1. Standards for New Construction

4. Historic Resources in Historic Districts will be more tightly regulated than City landmarks.

5. Respecting the historic building and district character versus creation of museums

3. First and second story front porch.

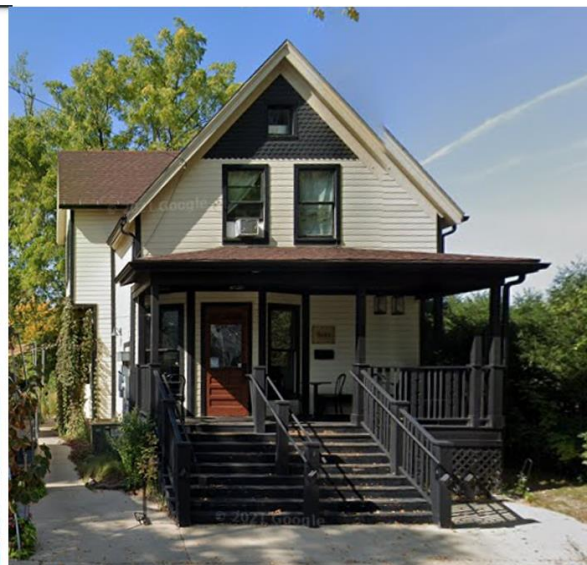
The two story front porch was approved in 1995. In 2019, the owner sought to move the center window on the second story and replace it with a door in order to access the second floor porch (Legistar 55997).

- The first story porch would likely not comply with the proposed ordinance: "Where physical evidence of the overall historic form and detailing are not evident, porch elements shall be

of a simple design found on similar historic resources within the district.” This porch has brackets and dentil frieze which could be deemed to not be a simple design.

- The second story porch is conjectural since no evidence existed for a second story porch and, thus, would be prohibited.
- The second story decorative window likely would not have been able to be turned into a door. The draft ordinance says: “Original decorative windows shall be repaired and retained” and “The removal of historic features on elevations visible from the developed public right-of-way is prohibited.”
